CITY OF VANCOUVER

POLICY REPORT DEVELOPMENT AND BUILDING

Date: January 6, 2006
Author: Michael Naylor
Phone No.: 604.871.6269
RTS No.: 05623
CC File No.: 11-3600-03
Meeting Date: January 17, 2006

SUBJECT: CD-1 Rezoning – Hillcrest and Nat Bailey Stadium Parks – Addendum

RILEY-HILLCREST-NAT BAILEY STADIUM PARK MASTER PLAN
Revised Plan approved by Park Board October 3, 2005

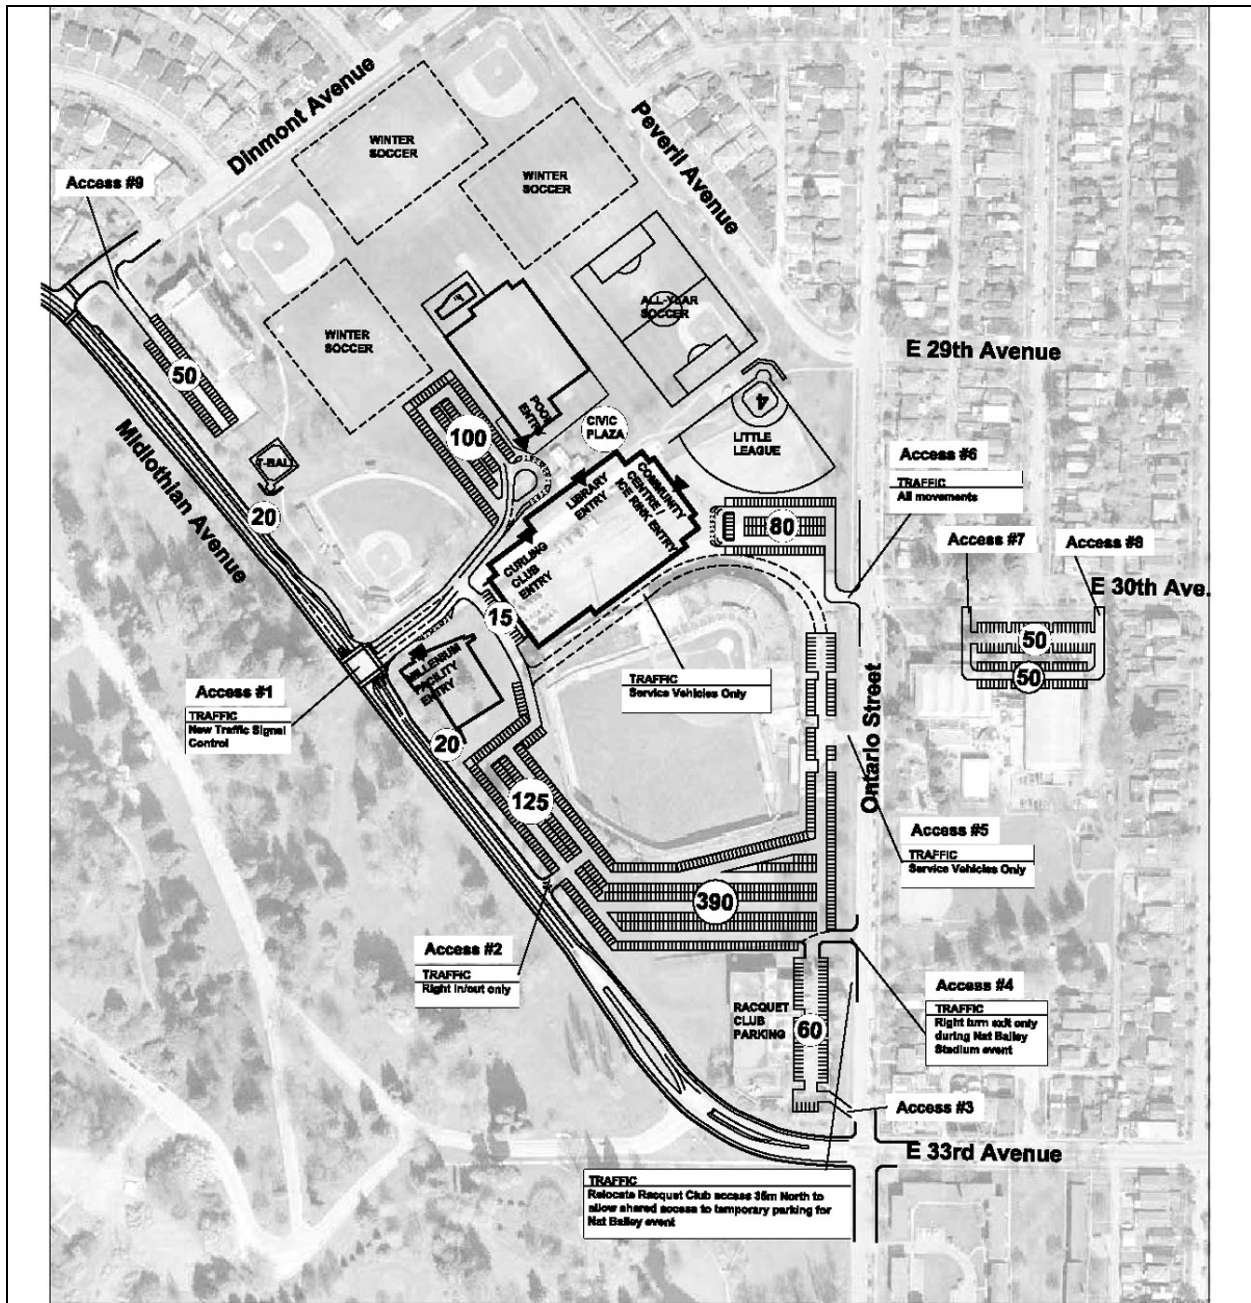
“THAT the Board approve the revised Hillcrest, Riley, Nat Bailey Parks Master Plan incorporating a modified parking and access arrangement as illustrated in Appendix [E] for the purpose of initiating the rezoning process and direct staff to:

Ensure that a maximum of 100 parking stalls be located adjacent to the Aquatic Centre and reallocation of some spaces throughout the site be pursued; and

- *Maximize the amount of permeable materials in parking areas;*
- *Reorient the temporary parking lot on the current community centre site to parallel Ontario Street;*
- *Ensure that land allocated for temporary parking is available for active park purposes;*
- *Relook at the number of exits and entrances on Ontario Street and consider right hand turn only for the parking lot adjacent to the new community centre;*
- *Ensure that the number of playing field spaces are maintained;*
- *Ensure that the building design of the aquatic centre should protrude into the park as little as possible provided that it can still accommodate a drop-off circle and civic square and preserve as many trees as possible on Clancy Loranger; and*
- *Review measures to reduce parking requirements once all the facilities are operational.”*
